## Product Change Notification / SYST-01VBUY730

PIC32MK General Purpose and Motor Control (GPK/MCM) with CAN FD Family Silicon Errata and Data Sheet Clarifications

**Description of Change:** Updated the entire document to reflect the new silicon revision, B4.

# PIC32MK General Purpose and Motor Control (GPK/MCM) with CAN FD Family Silicon Errata and Data Sheet Clarifications

## 2.2.2 VBUS pin

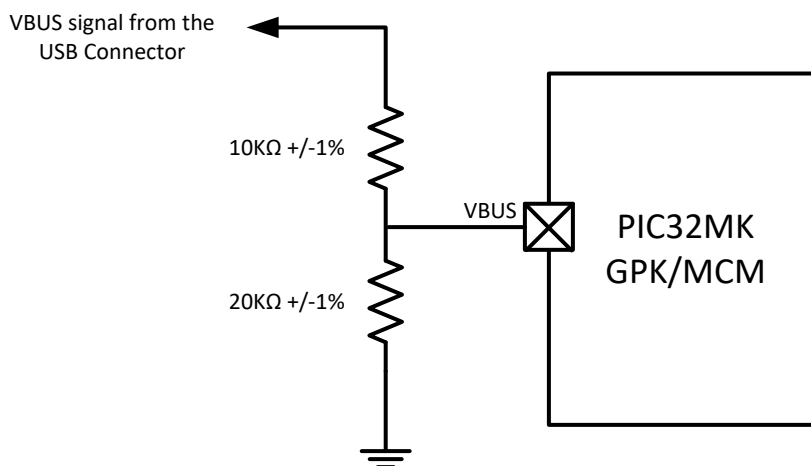
The VBUS pin is not 5V tolerant.

Connect an external voltage divider as shown in the following figure:
